Pole Position II Enhancement Instructions

TM-255 Pole Position II

©1983 by Atari, Inc

Figure 2 Attraction Glass and Display Shield Replacement

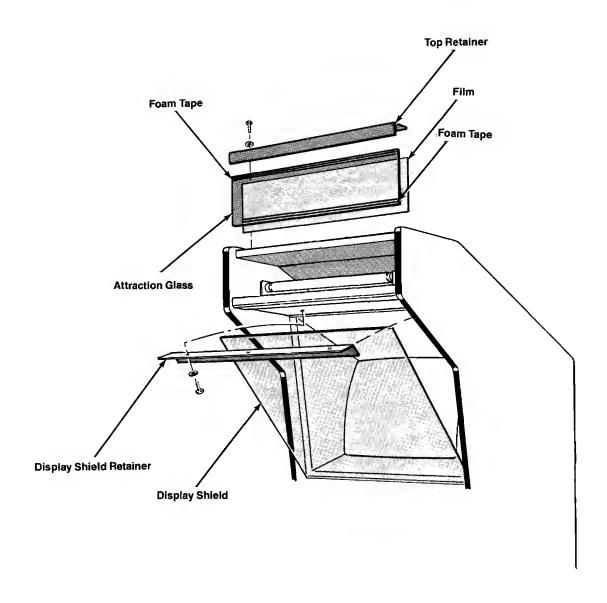
- 1. Use the 1/8-inch Allen wrench to remove the three screws and washers that fasten the top retainer to the cabinet. Remove the retainer. Save the retainer, washers, and screws for reassembly.
- 2. Loosen the three screws that fasten the bottom retainer to the cabinet.
- 3. Remove and discard the attraction glass. If there is a film behind it, remove and discard the film also.
- 4. Take the attraction glass, attraction film, and foam tape out of the enhancement kit. Place a strip of foam tape lengthwise along the top and bottom of the attraction glass. The tape on the glass should be toward you.
- 5. Put the attraction film behind the attraction glass. You should be able to read the film. Place the attraction glass and film in the bottom retainer.
- 6. Tighten the screws in the bottom retainer.
- 7. Reinstall the top retainer, using the washers and screws you saved in step 1.

- 1. Use the 1/8-inch Allen wrench to remove the screws and washers that hold the display shield retainer in place. Save this hardware for reassembly.
- 2. Lift the display shield out of the cabinet.
- Install the display shield contained in the enhancement kit.

Figure 3 Atari PCB Components Affected by Enhancement

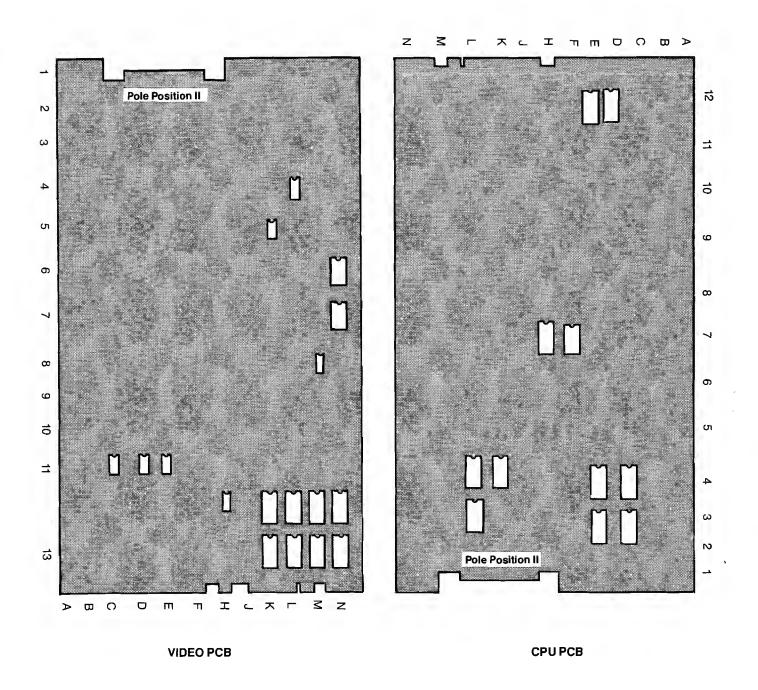
Modifications to the Atari PCB set include replacing and addding integrated circuits and sockets to both the CPU PCB and the Video PCB. Be sure to observe the precautions given previously under "Soldering Precautions."

1. Using the method shown in Figure 9, remove the integrated circuits at locations 3E, 3L, 4E, 4L, 7F, 7H, 12E, and 12F from their sockets.

- 2. Using the proper soldering techniques, remove the solder from the plated-through holes at locations 3D, 4D, and 4K.
- 3. Remove three 28-contact IC sockets from the enhancement kit and install them on the PCB at locations 3D, 4D, and 4K. Be sure to observe the proper placement of the socket index as shown on the PCB.
- 4. Using the information given in Table 4, remove each specified IC from the enhancement kit and install it in the proper socket.

- 1. Using the method shown in Figure 9, remove the integrated circuits at locations 6N, 7N, 12K, 12L, 13K, 13L, and 13N from their sockets.
- 2. Using the method given under "Removing Integrated Circuits," remove the soldered-in IC at locations 4L, 5K, 8M, 11C, 11D, 11E, and 12H.
- 3. Remove the 24-contact IC sockets from the PCB at locations 6N and 7N.
- 4. Using the information given in Table 5, remove the appropriate IC sockets from the enhancement kit and install each in the specified location.

IC Part No.	CPU PCB Location
136014-176	3L
136014-177	4L
136014-178	3E
136014–179	4 E
136014-180	7 H
136014-181	12F
136014182	12E
136014-183	7 F
136014-184	3D
136014-185	4D
137351-001	4K

No. of Contacts	Install at Location:
16	5K
16	SK 8M
16	110
16	110
16	11E
18	4L
18	12Н
28	6N
28	7N
28	12M
28	13M

IC Part No.	Video PCB Location
136014-166	13K
136014-167	12K
136014-168	13L
136014–169	12L
136014-170	13N
136014-171	12N
136014-172	7N
136014–173	6N
136014-174	12M
136014-175	13M
136014-186	11E
136024–187	11D
136014-188	11C
136014-189	8M
136014-190	5K
136014-191	4L
136014-192	12H

Figure 4 Namco PCB Components Affected by Enhancement

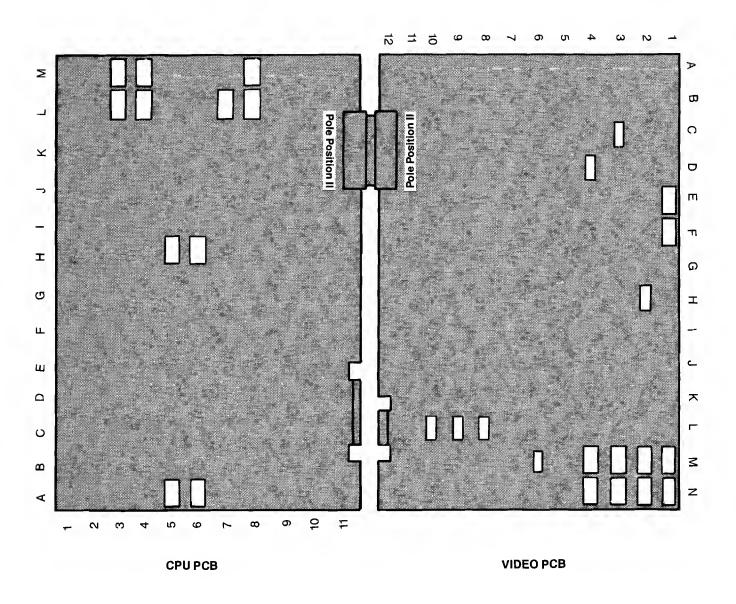
Modifications to the Namco PCB set include replacing and adding integrated circuits and sockets to both the CPU PCB and the Video PCB. Be sure to observe the precautions given previously under "Soldering Precautions."

1. Using the method shown in Figure 9, remove the integrated circuits at locations 4M, 8M, 4L, 8L, 5H, 6H, 5A, and 6A from their sockets.

- 2. Using the proper soldering techniques, remove the solder from the plated-through holes at locations 3M, 3L, and 7L.
- 3. Remove three 28-contact IC sockets from the enhancement kit and install them on the PCB at locations 3M, 3L, and 4L. Be sure to observe the proper placement of the socket index as shown on the PCB.
- 4. Using the information given in Table 7, remove each specified IC from the enhancement kit and install it in the proper socket.

- 1. Using the method shown in Figure 9, remove the integrated circuits at locations 1E, 1F, 4M, 3M, 1M, 4N, 3N, and 1N from their sockets.
- 2. Using the method given under "Removing Integrated Circuits," remove the soldered-in IC at locations 3C, 4D, 2H, 10L, 9L, 8L, 6M, and 2N.
- 3. Remove the 24-contact IC sockets from the PCB at locations 1E and 1F.
- 4. Using the information given in Table 8, remove the appropriate IC sockets from the enhancement kit and install each in the specified location.

IC Part No.	CPU PCB Location	,
136014–176	8M	
136014-177	8L	
136014-178	4M	
136014–179	4L	
136014-180	6н	
136014-181	6A	
136014-182	5A	
136014–183	5н	
136014-184	3M	
136014-185	3L	
137351-001	$7\mathrm{L}$

No. of Contacts	Install at Location:	_
16	2H	
16	8L	
16	9L	
16	10L	
16	4D	
18	6M	
18	8C	
28	1E	
28	1F	
28	2M	
28	2N

•	
IC Part No.	Video PCB Locations
136014-166	4N
136014-167	4M
136014-168	3N
136014–169	3M
136014-170	1N
136014-171	1M
136014-172	1 F
136014–173	1E
136014-174	2M
136014-175	2N
136014-186	8L
136014–187	9L
136014-188	10L
136014-189	2H
136014-190	4D
136014-191	3C
136014-192	6M

Figure 10 Display Shield Replacement—Sit-Down

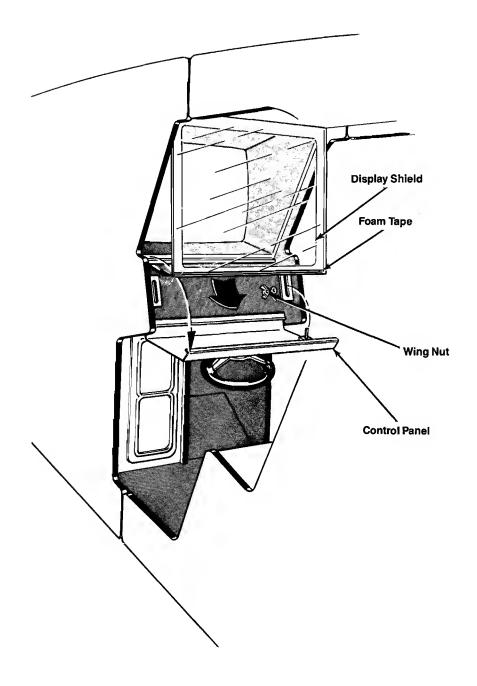
- 1. Open the access panel at the rear of the game.
- 2. Reach toward the front of the game, and remove the wing nuts and washers that secure the control panel to the game cabinet. (Someone should hold the control panel against the cabinet as you do this!) Save this hardware for reassembly later.
- 3. Pull the bottom of the display shield toward you. Remove and discard this shield.
- 4. Apply a strip of foam tape to the front bottom of the display shield provided in the enhancement kit.
- 5. Insert the Pole Position II display shield. Close the control panel. Someone should hold the control panel against the cabinet as you reinstall the hardware.
- 6. From behind the cabinet, reinstall the wing nuts and washers you saved in step 1.
